**New Barnet Community Association**  
Community Centre, 48/50 Victoria Road, New Barnet, EN4 9PF  
020 8441 7044  
newbarnetca@gmail.com  
Registered Charity No. 1070455  
Registered Company No. 3564623

### **REQUEST FOR JOHN DIX/NICK HUFTON TO SPEAK AT COMMITTEE**

#### **Application No 23/3964/FUL – Land Formerly Known As British Gas Works Albert Road New Barnet EN4 9SH**

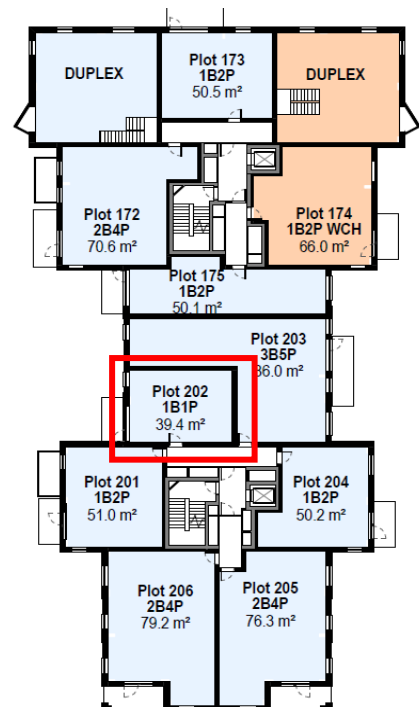
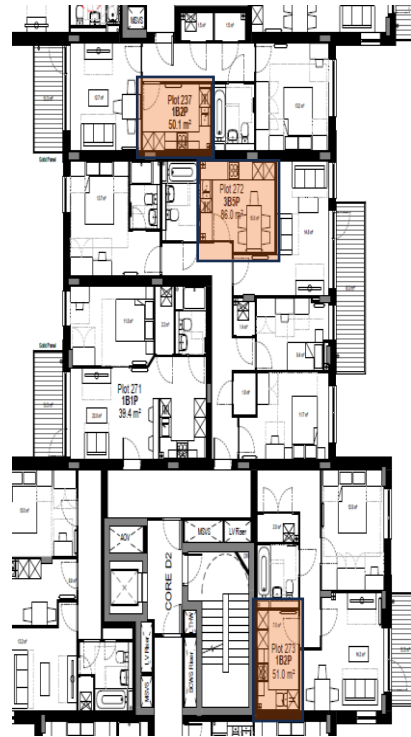
**Daylight/Sunlight: Breach of BRE 209 (2022) guidelines.** In the refused scheme, 6% of rooms failed to meet the BRE guidelines. In the current application, the Updated Daylight & Sunlight report states that 323 of the 1,277 rooms or 25% of rooms fail to meet the daylight illuminance target, with 27% of living rooms and 95% of kitchens failing to meet the target. As such this is significantly worse than the refused scheme which the Inspector noted as a contributing factor for refusal. It appears that part of the reason for the failure to meet the guidelines is related to the proportion of single aspect flats and the reduction in glazing to window openings as detailed in Section 8 of the Design & Access Statement (page 114). In addition, having studied the plans in detail, it appears that 62 of the kitchen/diners have been

designed as internal rooms with no windows whatsoever (three are illustrated in shading in the plan opposite). As such, cooking and eating will require the lights to be switched on whenever the room is used and the rooms will rely on mechanical ventilation.
